APPENDIX 12

12A ANSWERS TO QUESTIONS

QUESTION 12A.2 (DRL 12.1) Discuss further the relationships between SMUD, Bechtel, B&W, WEC, and others. This discussion should include a list of the subsystems and support functions provided by the principal parties.

FIGURE 12A.5-1
BECHTEL CORPORATION
VERNON DIVISION ORGANIZATION
RANCHO SECO PROJECT

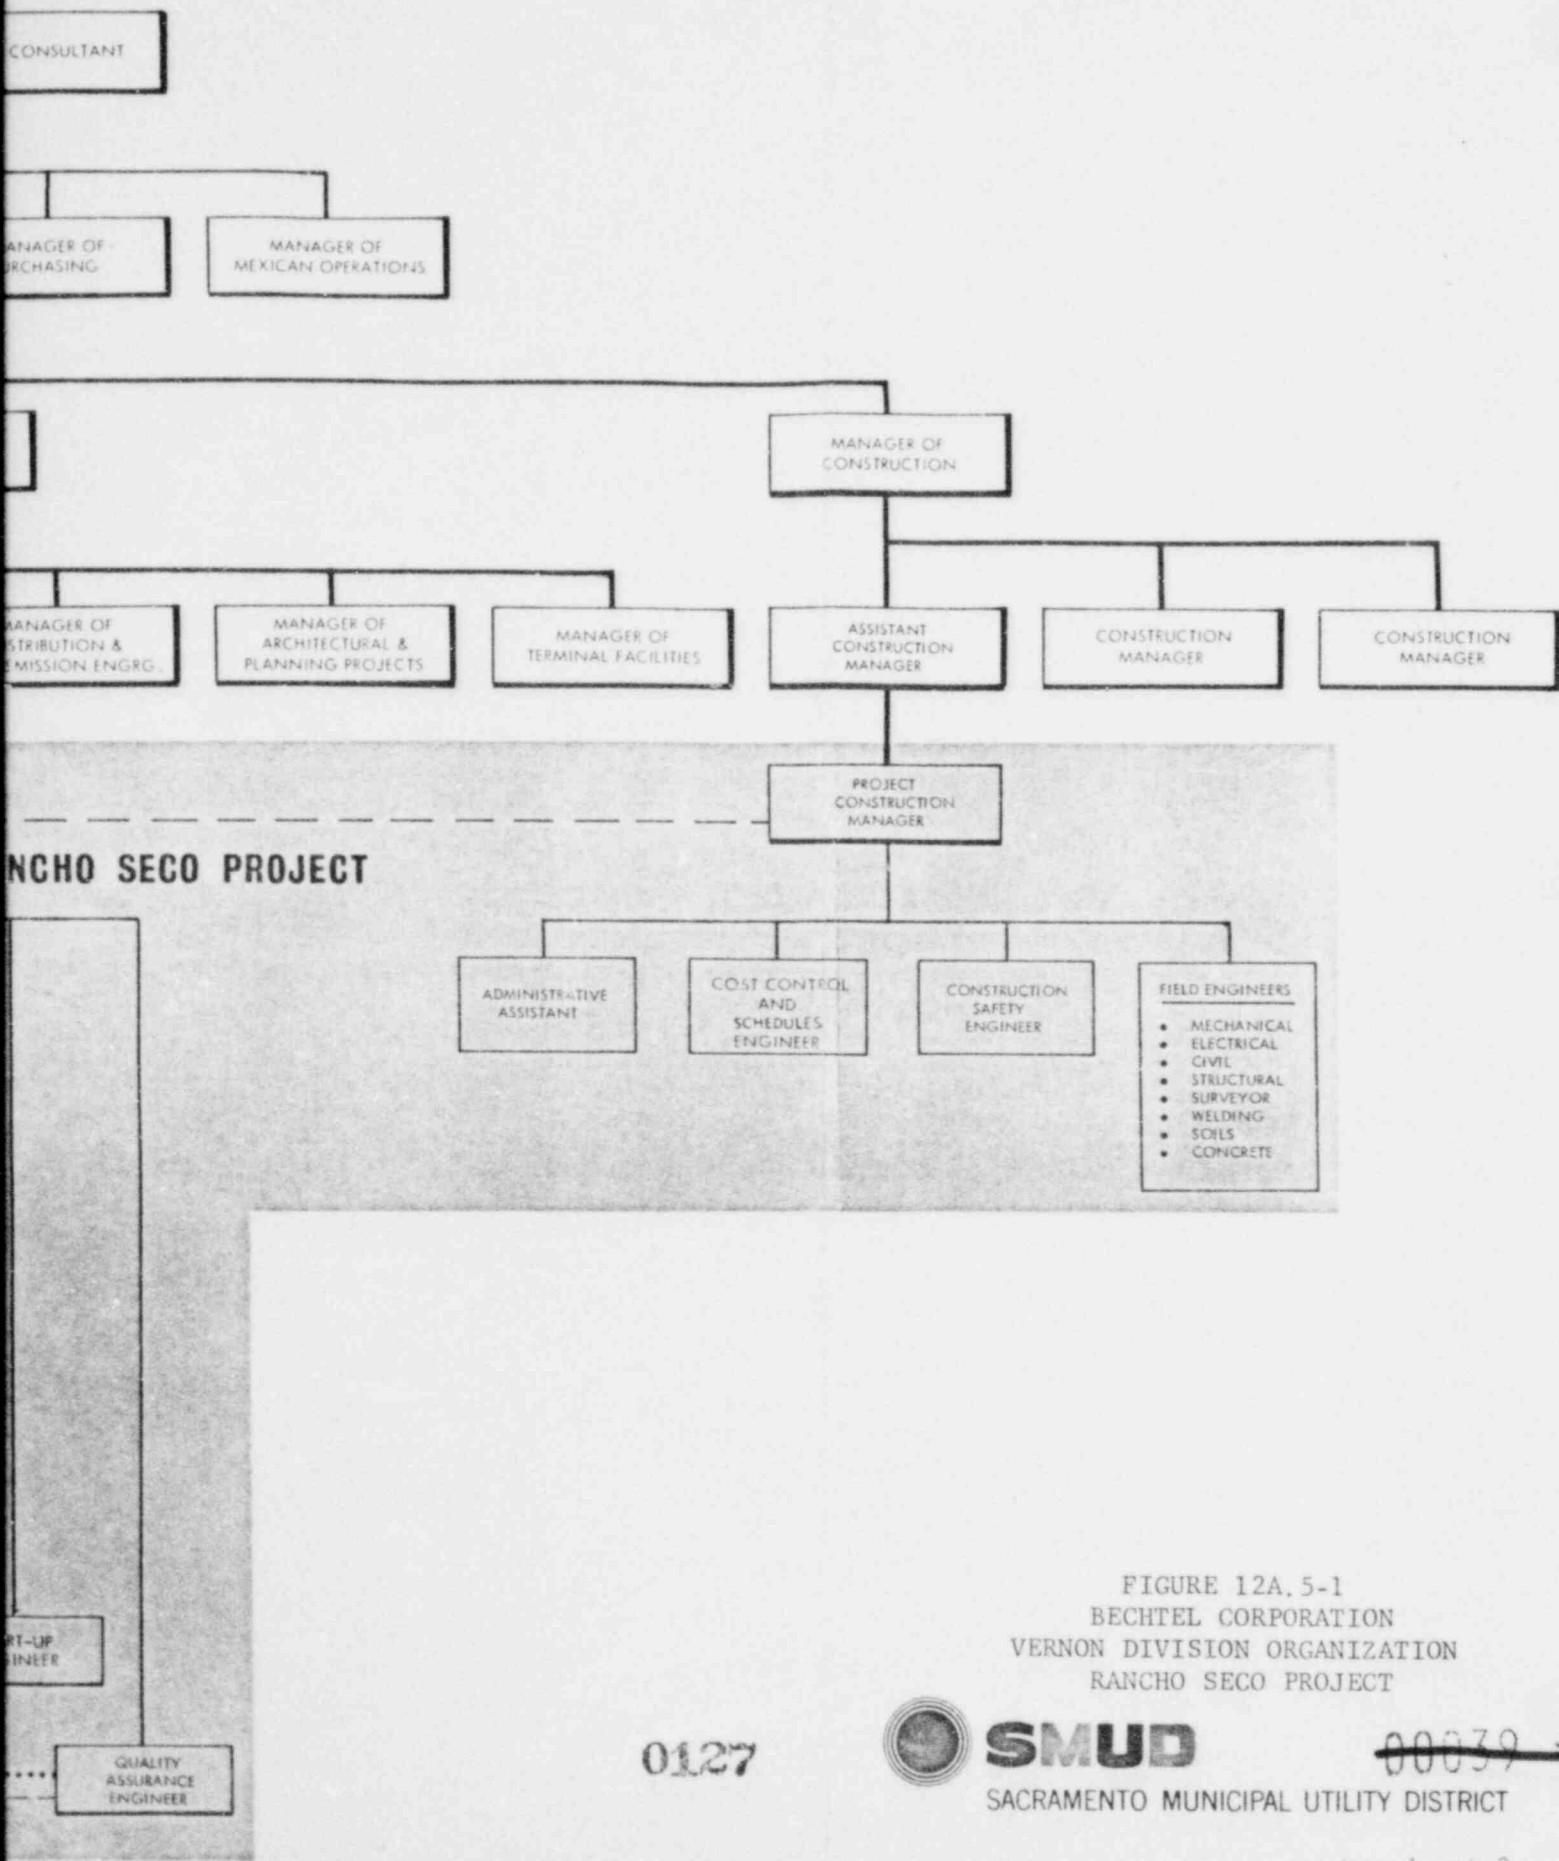
QUESTION Submit an organizational chart for the Bechtel Corporation
12A.5 indicating responsibility channels for Quality Assurance and
(DRL 12.4) Quality Control efforts for this project. Delineate home office
 as well as site groups.

ANSWER The organizational chart for the Bechtel Corporation indicating
 responsibility channels for Quality Assurance and Quality Con-
 trol is shown in Figure 12A.5-1.

FIGURE 12A.6-1
THE BABCOCK AND WILCOX COMPANY
BOILER DIVISION-QUALITY CONTROL
AND INSPECTION ORGANIZATION

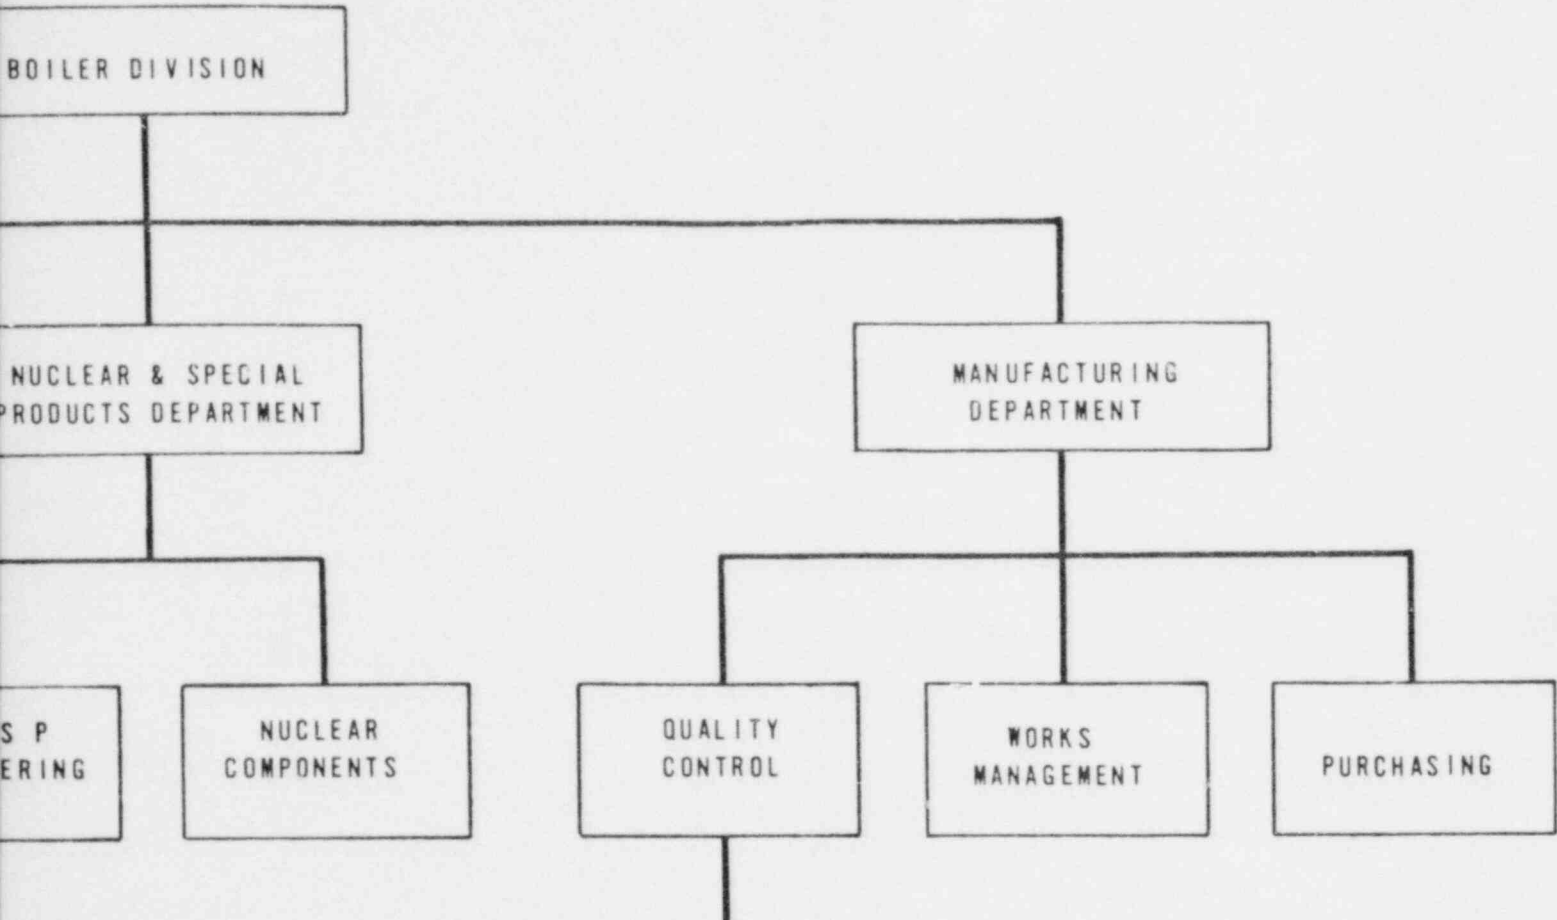
QUESTION Submit an organizational chart for the Babcock and Wilcox
12A.6 Company indicating responsibility channels for Quality Assurance
(DRL 12.5) and Quality Control efforts.

ANSWER The organizational charts for the Babcock and Wilcox Company
indicating responsibility channels for Quality Assurance and
Quality Control efforts are shown in Figures 12A.6-1, 2 and 3.

FIGURE 12A.6-2
 THE BABCOCK AND WILCOX COMPANY
 BOILER DIVISION-QUALITY CONTROL
 AND INSPECTION ORGANIZATION

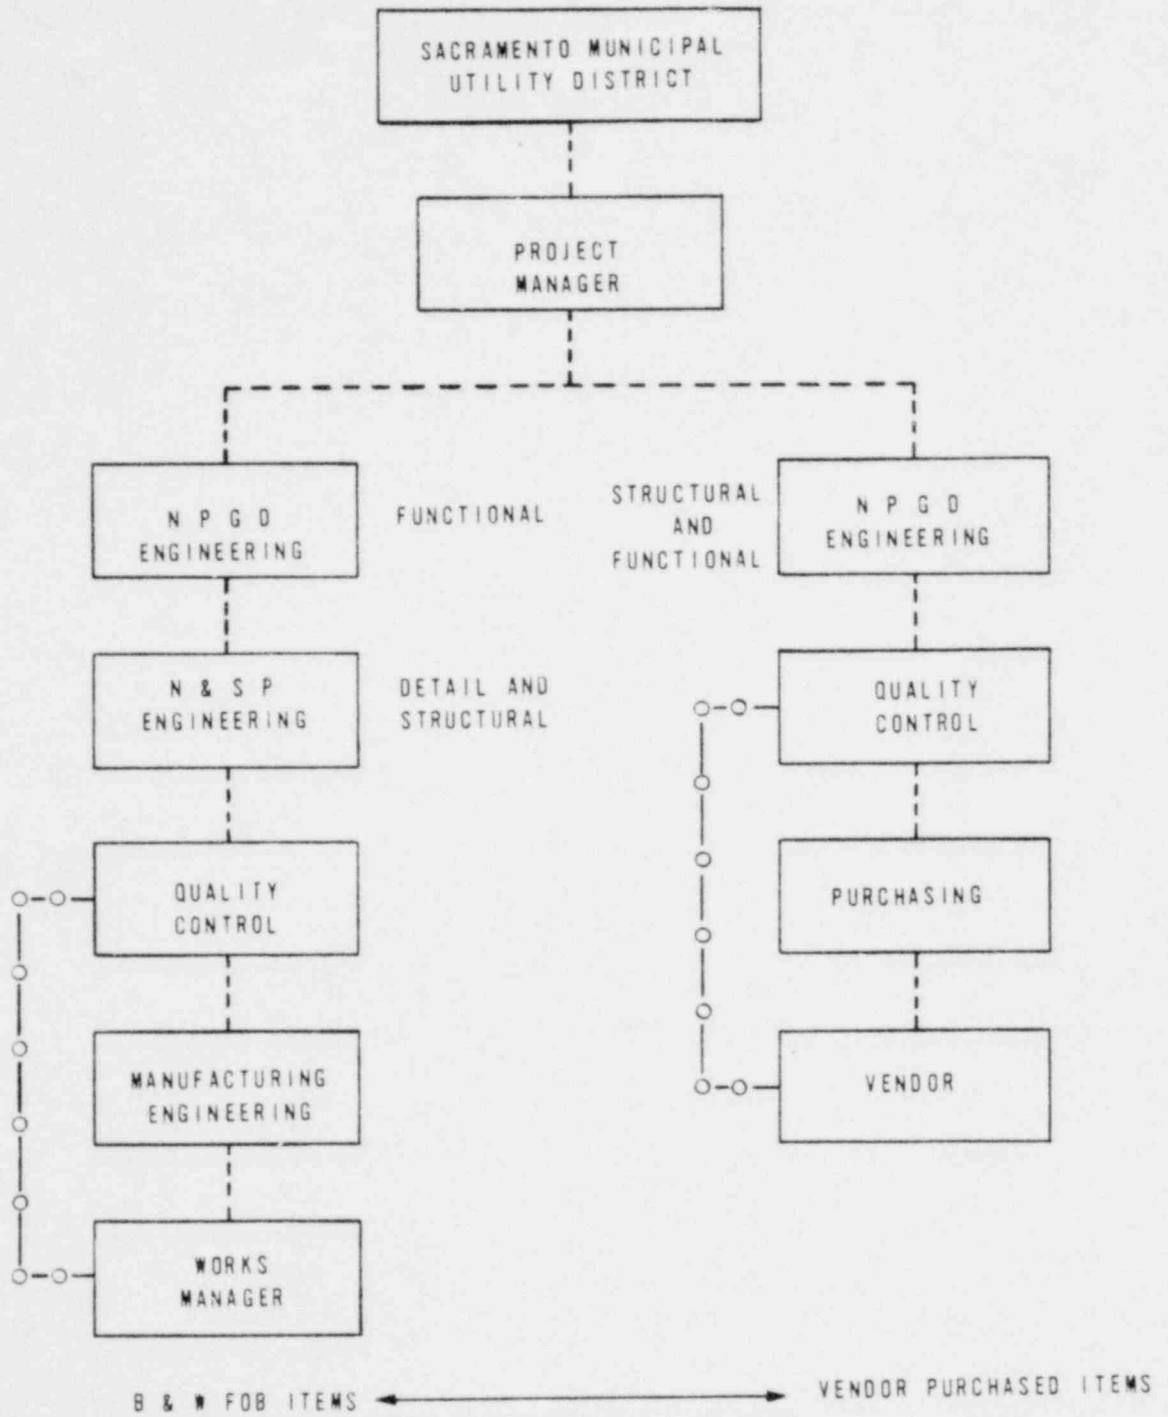
QUESTION 12A.6 (DRL 12.5) Submit an organizational chart for the Babcock and Wilcox Company indicating responsibility channels for Quality Assurance and Quality Control efforts.

ANSWER The organizational charts for the Babcock and Wilcox Company indicating responsibility channels for Quality Assurance and Quality Control efforts are shown in Figures 12A.6-1, 2 and 3.
